**1120 John Street**

**Onni Group**

**DRB Recommendation Meeting**

**SDCI Project #3030079**

DRB #1 Thomas Street Elevation

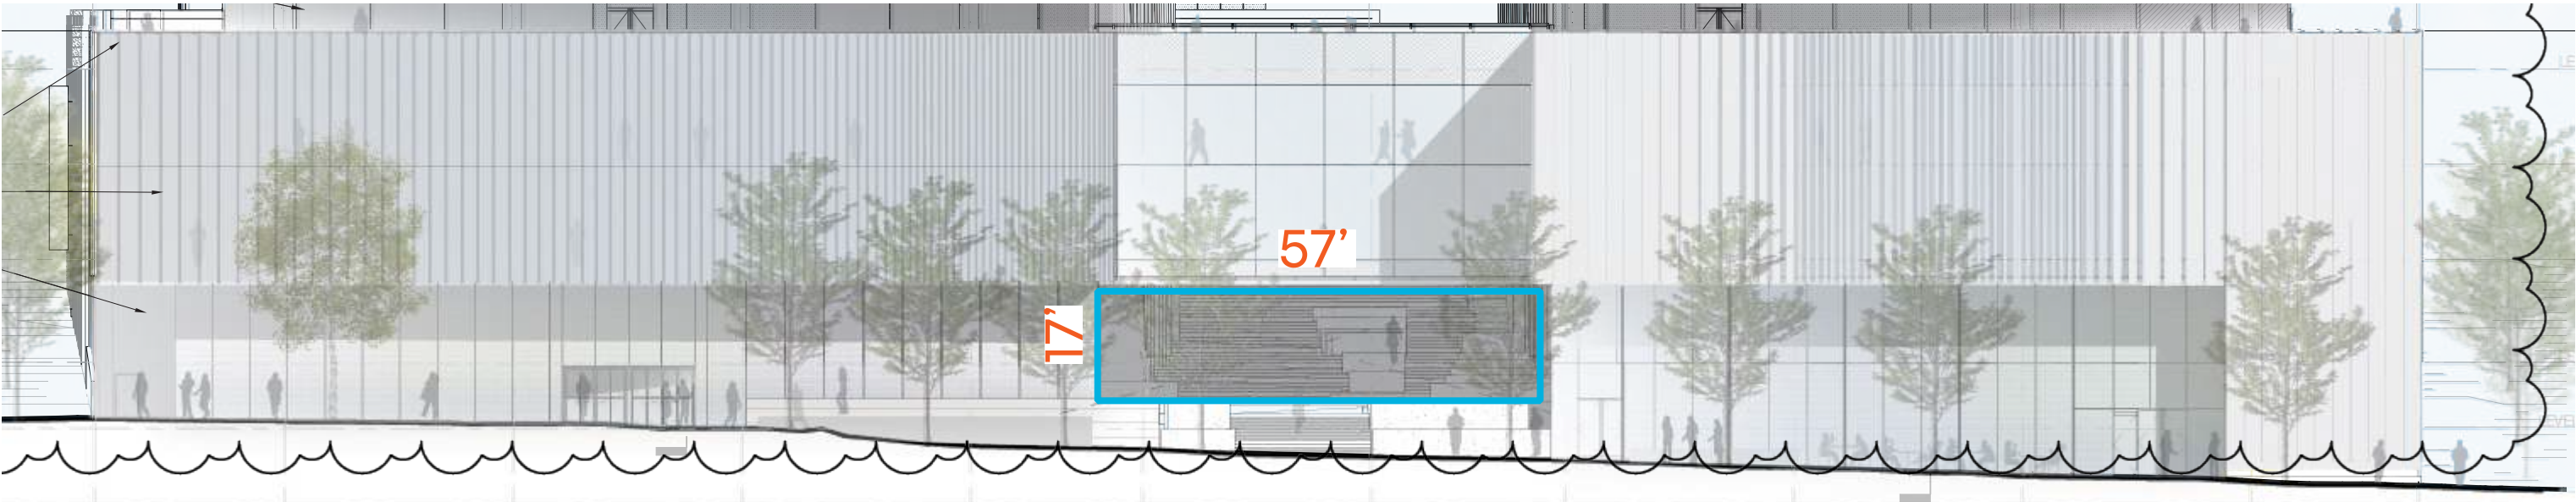
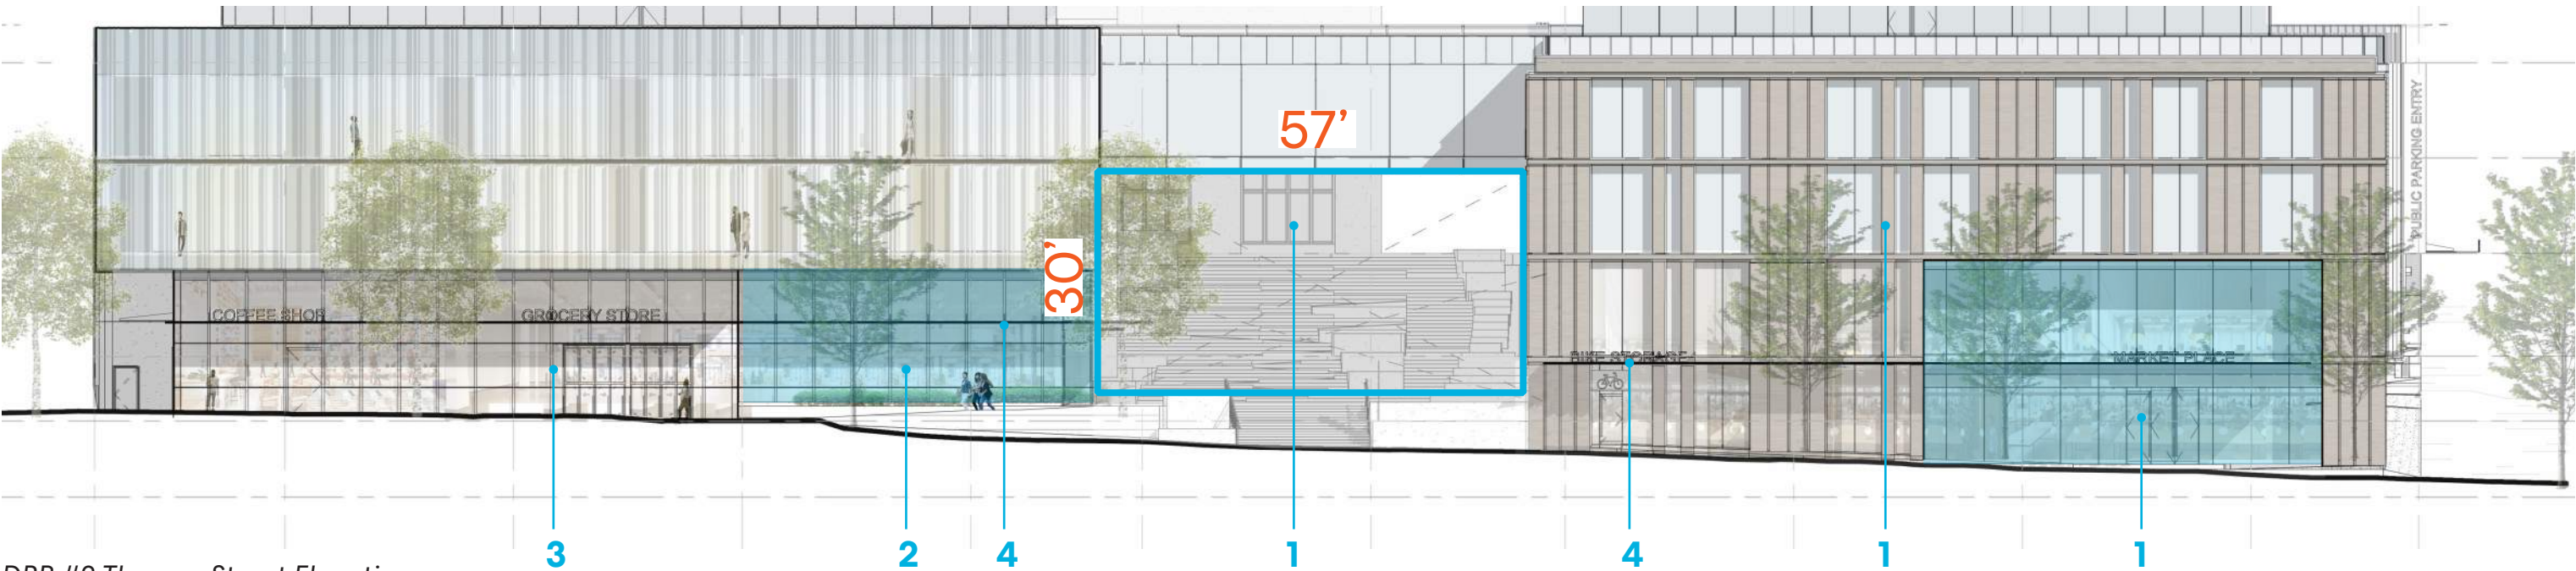
The Board also expressed concern regarding the vertical clearance of the passage and directed the applicant to provide a study with a higher single-story bridge, similar to the other more successful bridges in the project. (CS2-4-c)

- 1. Lower half of the Thomas bridge was removed increasing the vertical clearance.
- 2. Facade recessed to increase modulation/signify entry, and create a welcoming space.
- 3. Expressed mullions added for human scale elements.
- 4. Canopies added for weather protection and to signify entry.
